<b>PROJECT REPORT COVER SHEET</b>	<b>NO. SNCH082-RPT-02</b>
		<b>VERSION 1.0</b>
		Page 1 of 60

Edwin I. Hatch Unit 2 SEISMIC WALKDOWN REPORT, RER SNC425082

Resolution of Fukushima Near-Term Task Force Recommendation 2.3: Seismic

Figure 3 – Empty Anchor Hole (2R42-S001B)

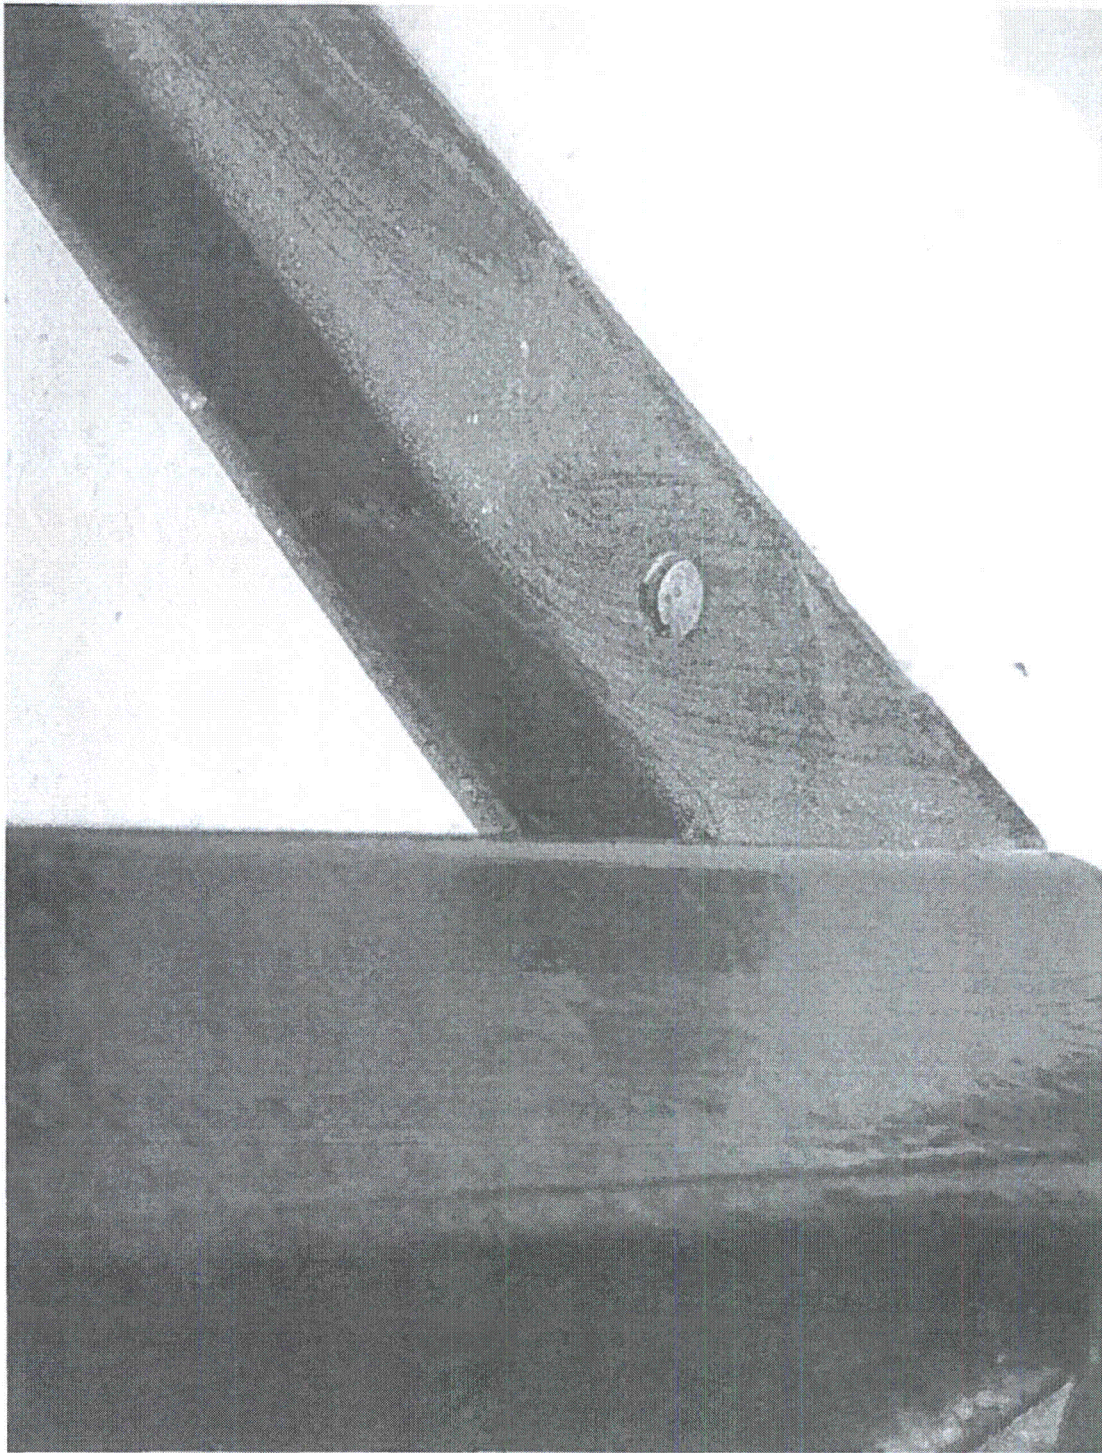
2. Is the anchorage free of bent, broken, missing or loose hardware? Y  N  U  N/A   
*There is one anchor missing from the support. Review of SEWS package 2R42-S001B shows that this anchor is noted to be missing and is not accounted for in the evaluation, so there is no potentially adverse seismic condition.*

Figure 4 – Mild Acid Residue on Bolts (2R42-S001B)

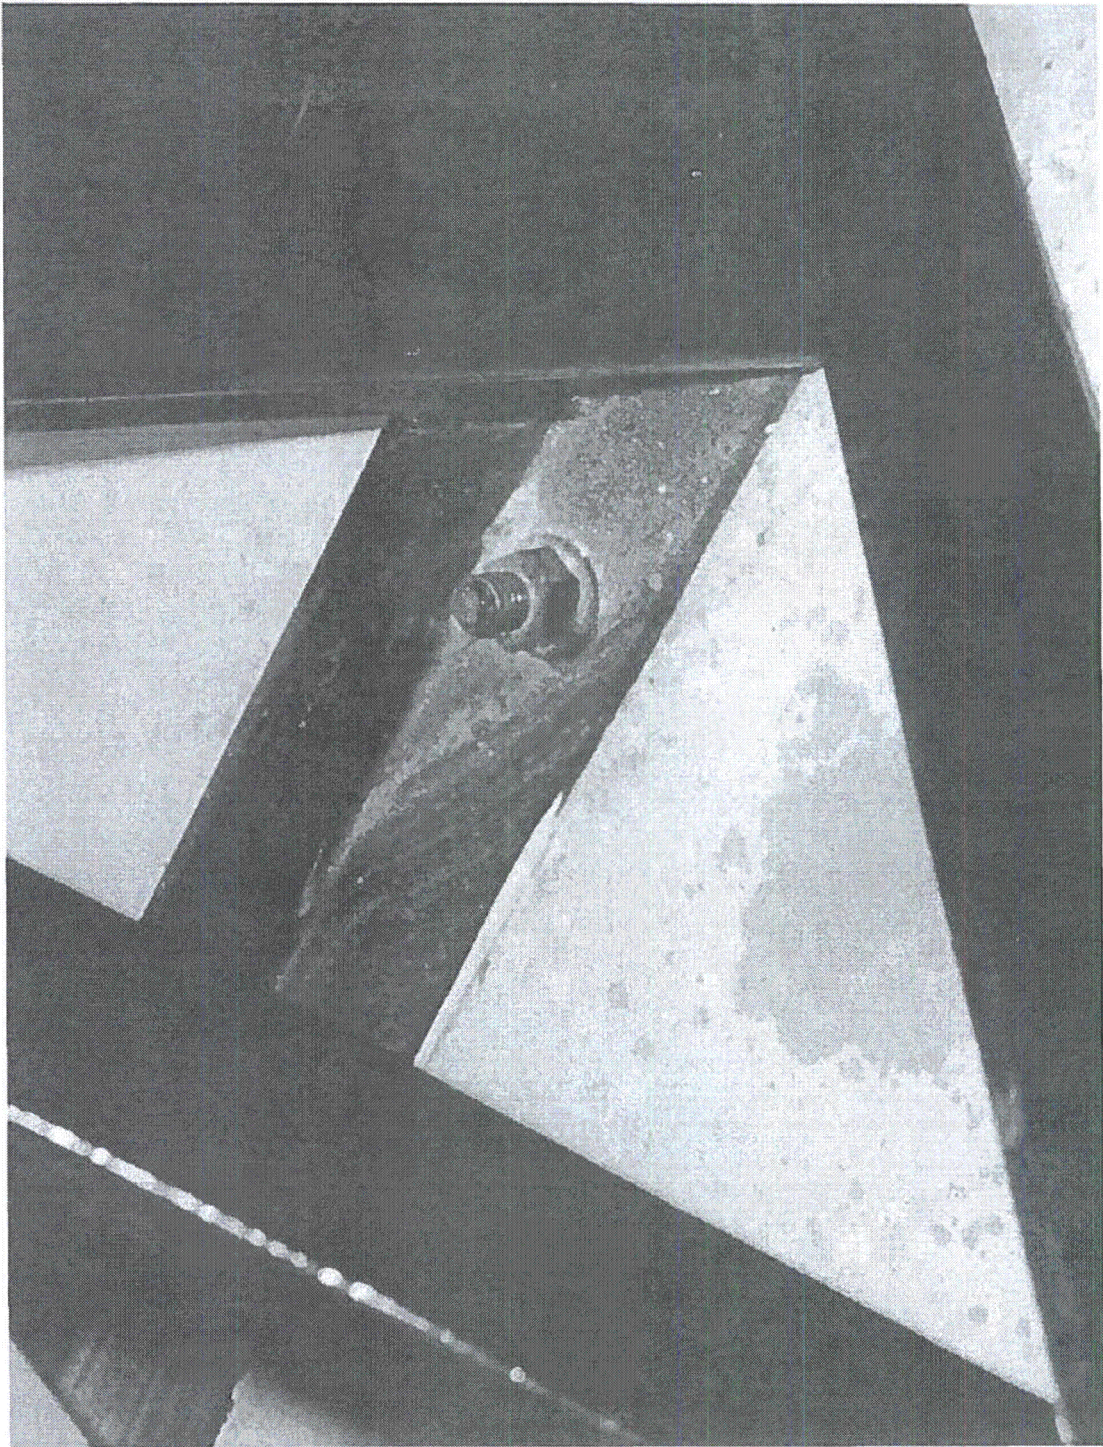
3. Is the anchorage free of corrosion that is more than mild surface oxidation? Y  N  U  N/A   
*There is some acid residue on the bolts from the batteries, but the paint has prevented any significant corrosion of the bolts. Since the corrosion is only on the surface, there is no potentially adverse seismic condition.*

3: Stains on Concrete Below Batteries (2R42-S002C)

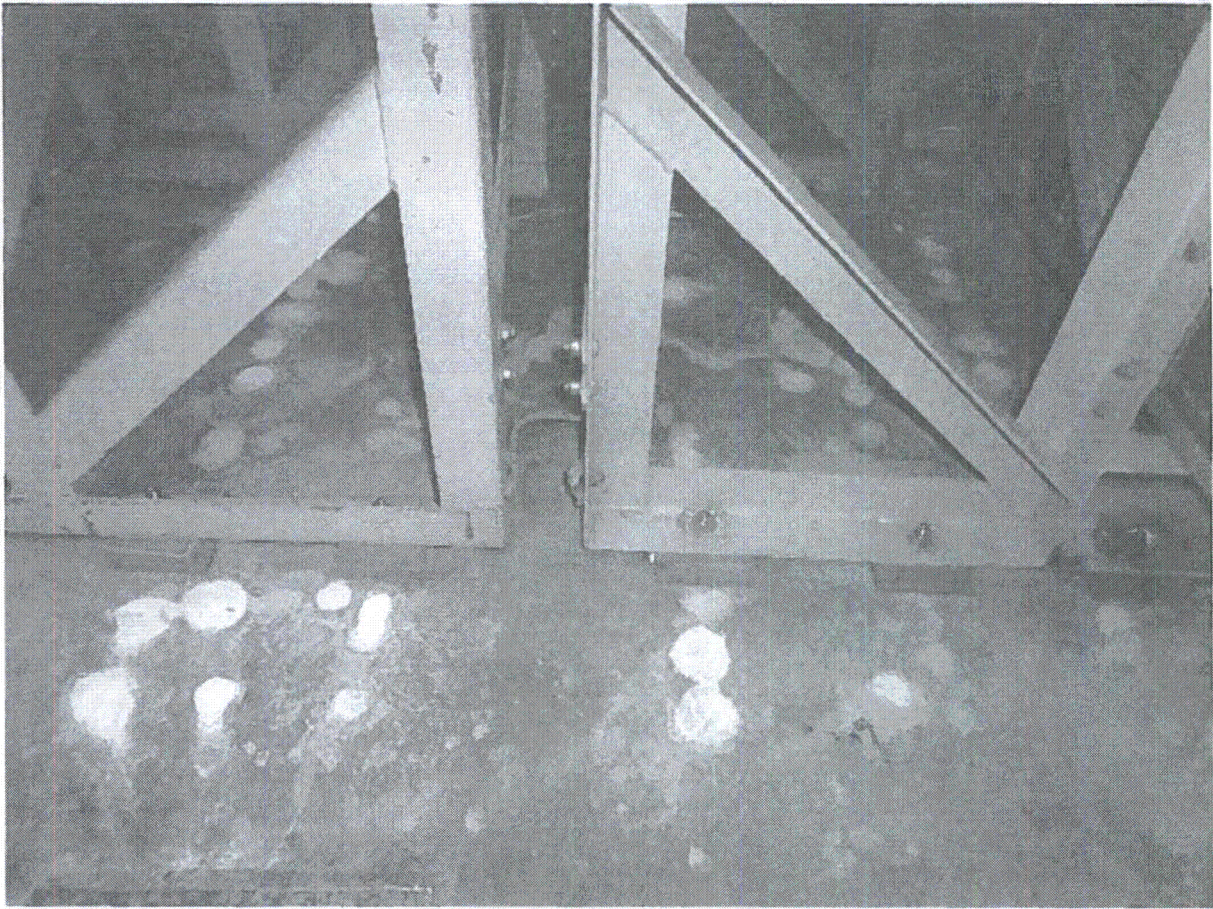
11. Have you looked for and found no other seismic conditions that could adversely affect the safety functions of the equipment? Y N U  
*The concrete surface below the batteries exhibited stains from some substance leaking in the area (see photograph 3). This is not a seismic concern.*

Figure 3 – Surface Oxidation on Middle Anchor (2R42-S017A)

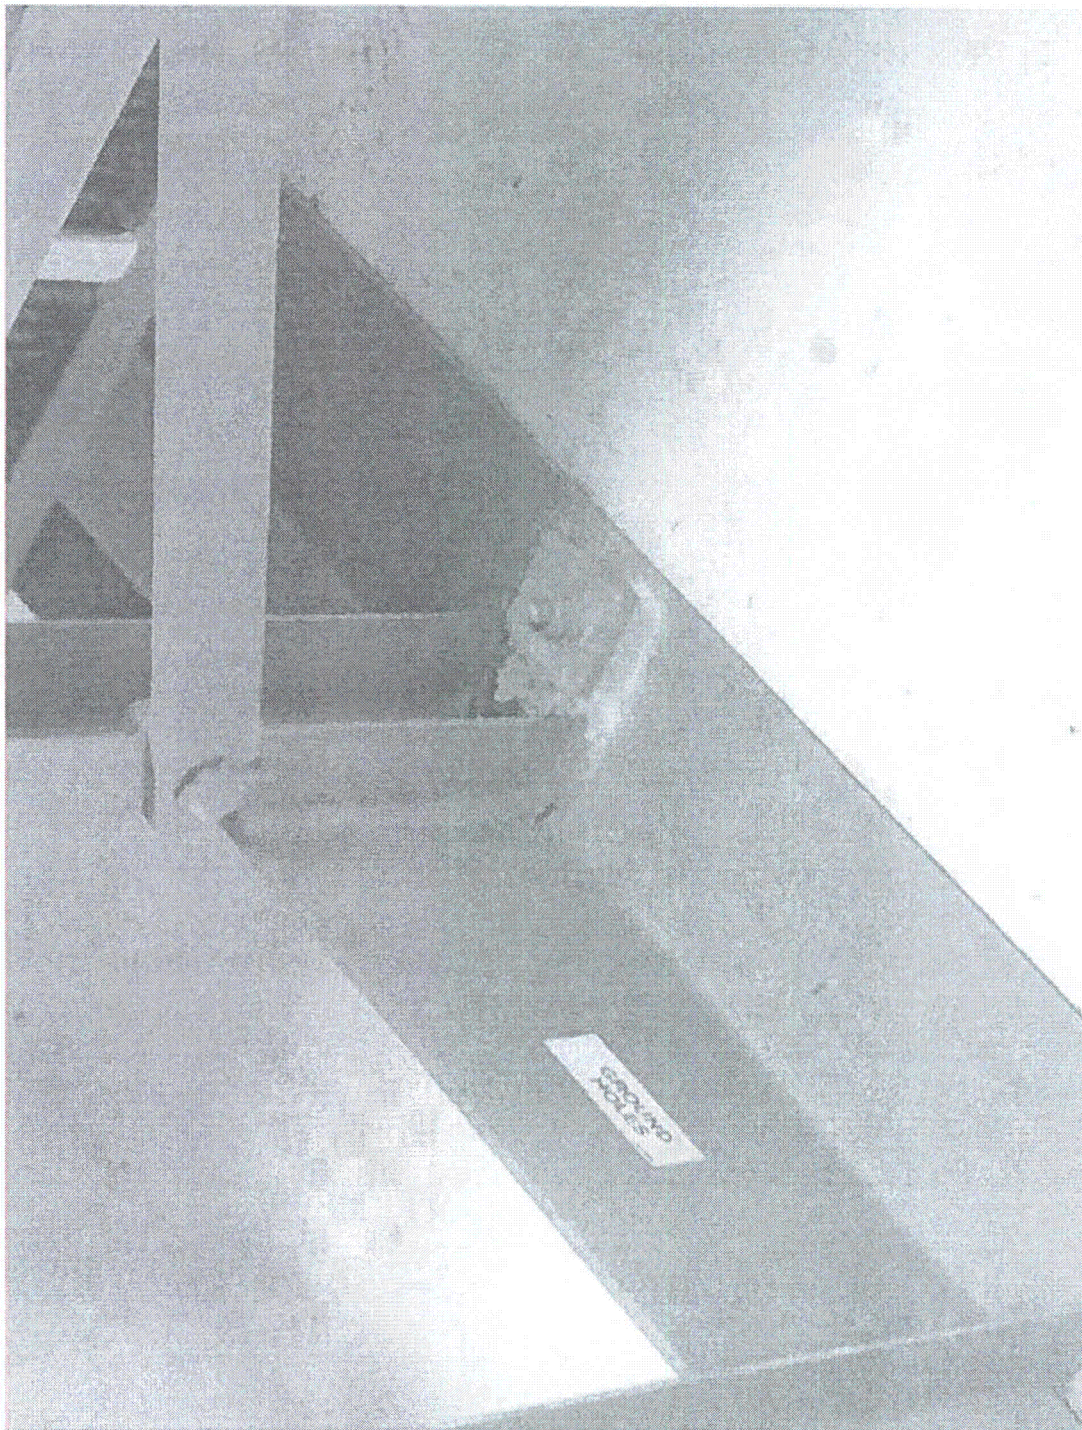
3. Is the anchorage free of corrosion that is more than mild surface oxidation? Y  N  U  N/A   
*There is mild surface oxidation on the middle anchor bolts. Since oxidation is only on the surface, the bolts are not degraded. Therefore, judged not to be a concern.*

Figure 4 – Attached Battery Line (2R42-S017A)

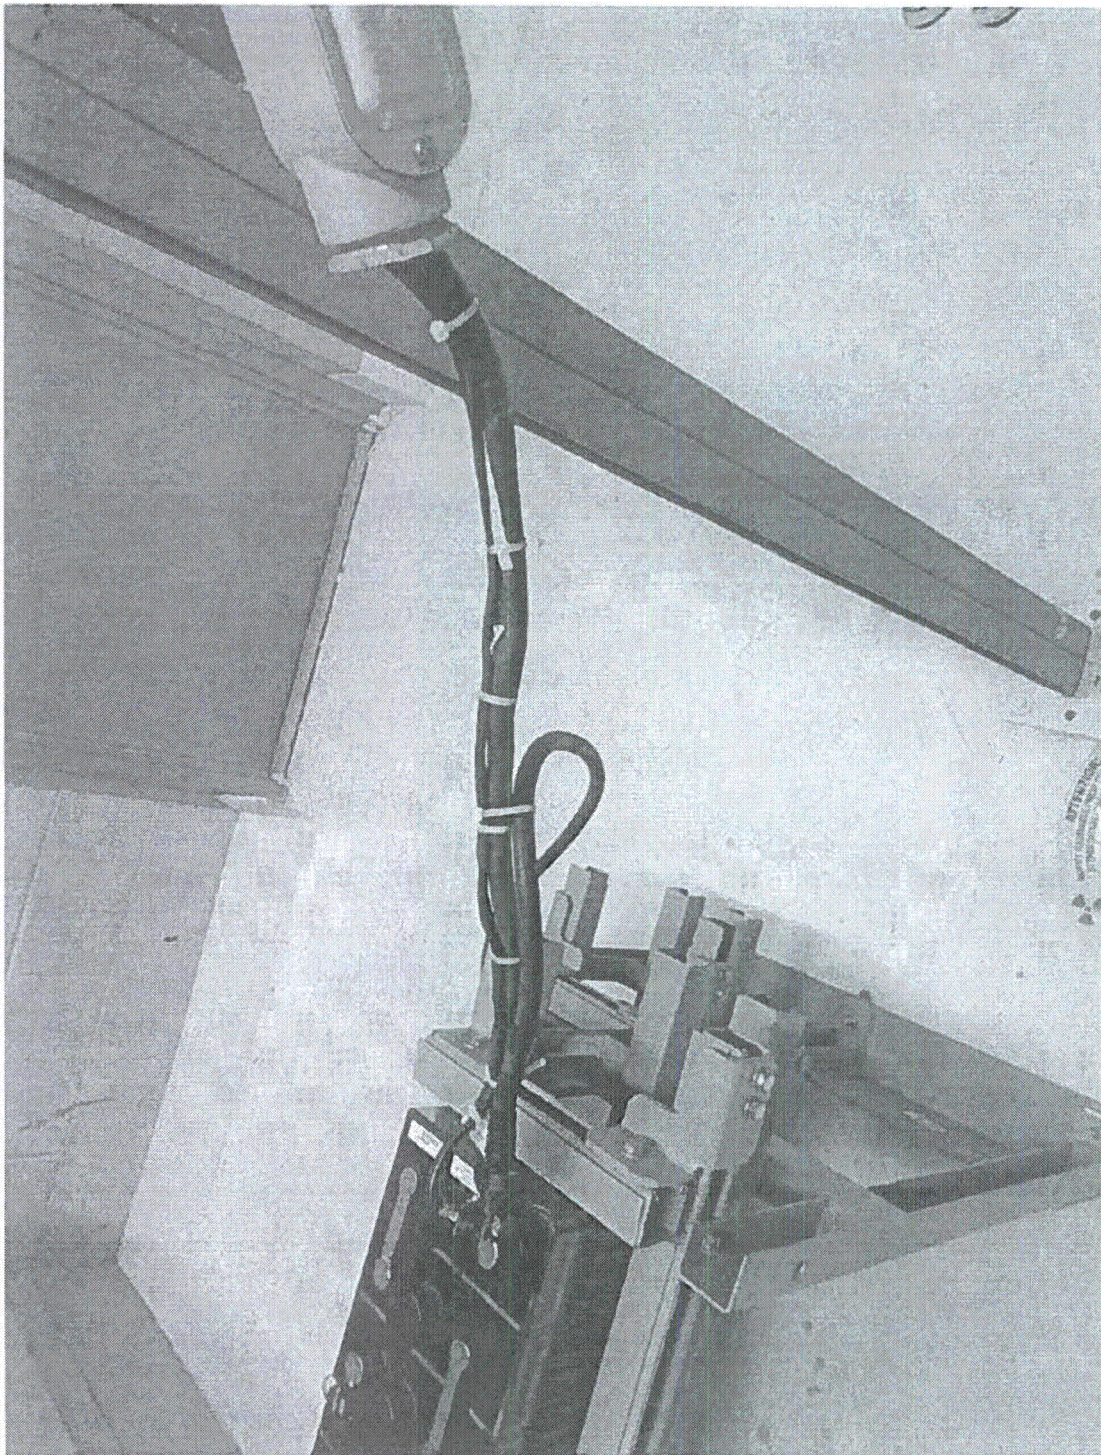
9. Do attached lines have adequate flexibility to avoid damage? Y  N  U  N/A   
*The line between the battery rack and the adjacent junction box support has relatively little slack. The battery and box supports are fairly rigid and the seismic acceleration at that elevation will be relatively low, so the differential movement between the components will be small. The slack in the conduit is judged sufficient to prevent any damage to the cables, so there is no potentially adverse seismic condition.*

Figure 3 – Surface Oxidation on Washer Plates (2R42-S017B)

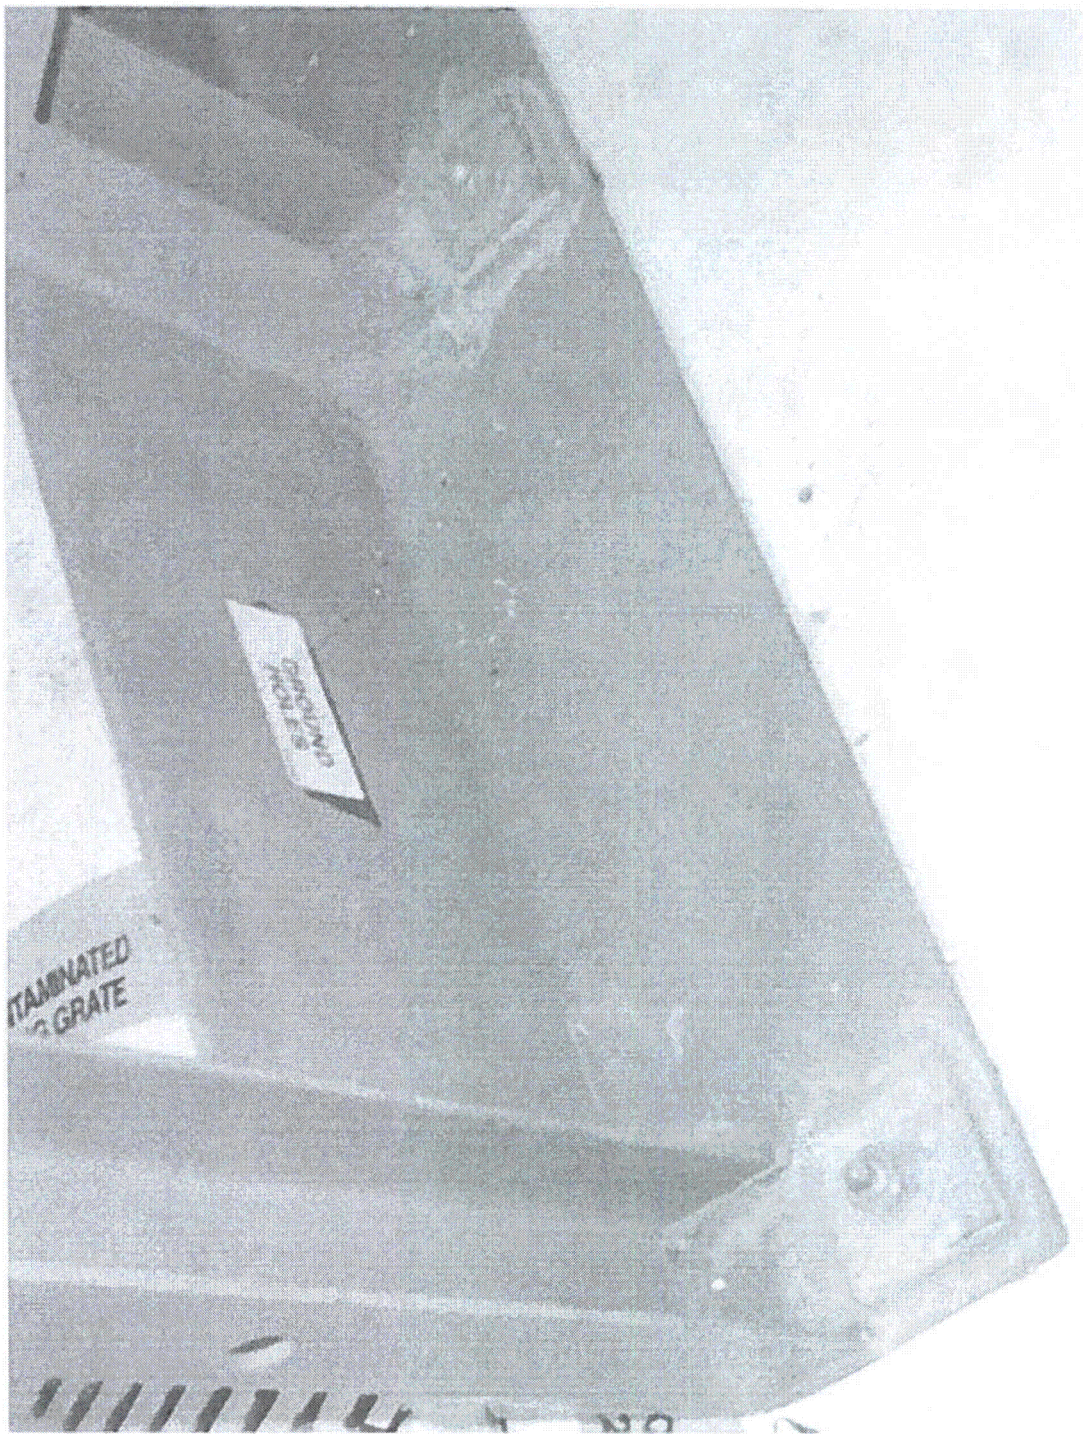
3. Is the anchorage free of corrosion that is more than mild surface oxidation? Y  N  U  N/A   
*There is mild surface oxidation on the component washer plates. Since oxidation is only on the surface, the bolts are not degraded. Therefore, judged not to be a concern.*

Figure 3 – Replaced Anchor Bolts (2R42-S026)

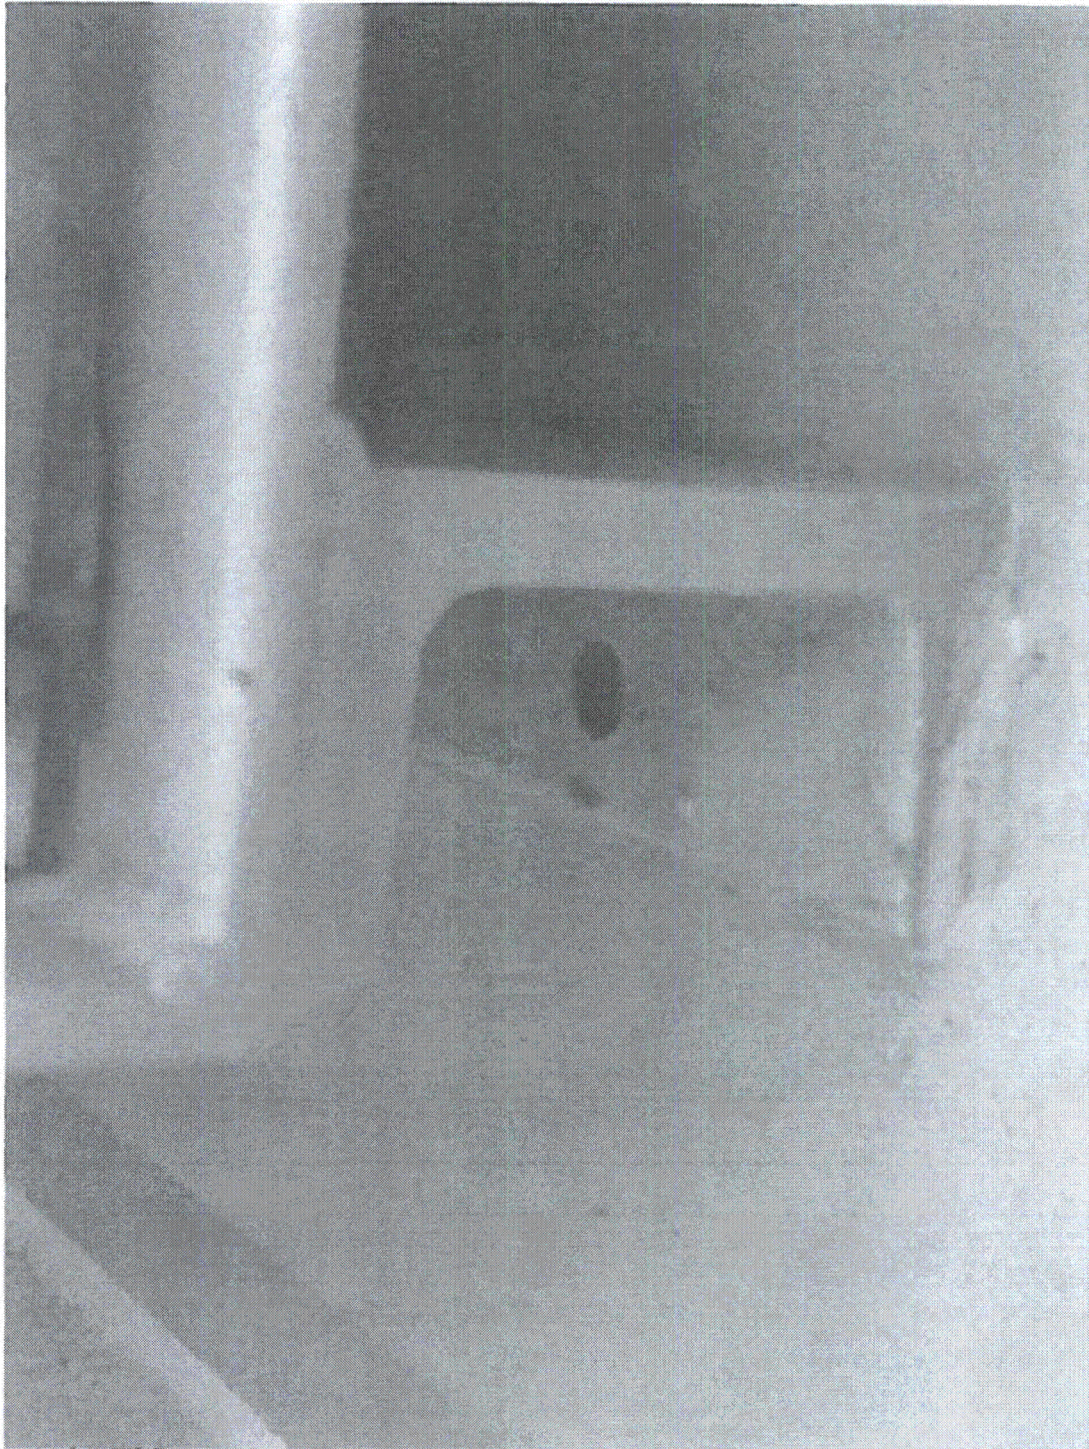
2. Is the anchorage free of bent, broken, missing or loose hardware? Y  N  U  N/A   
*There are two anchor bolt holes without anchor bolts. However, review of SEWS packages 2R42-S026 and S029 show that the anchors were replaced with welds, so there are no missing anchors. The existing welds have been verified against the SEWS packages and found to be in compliance. Therefore, there is no potentially adverse seismic condition.*
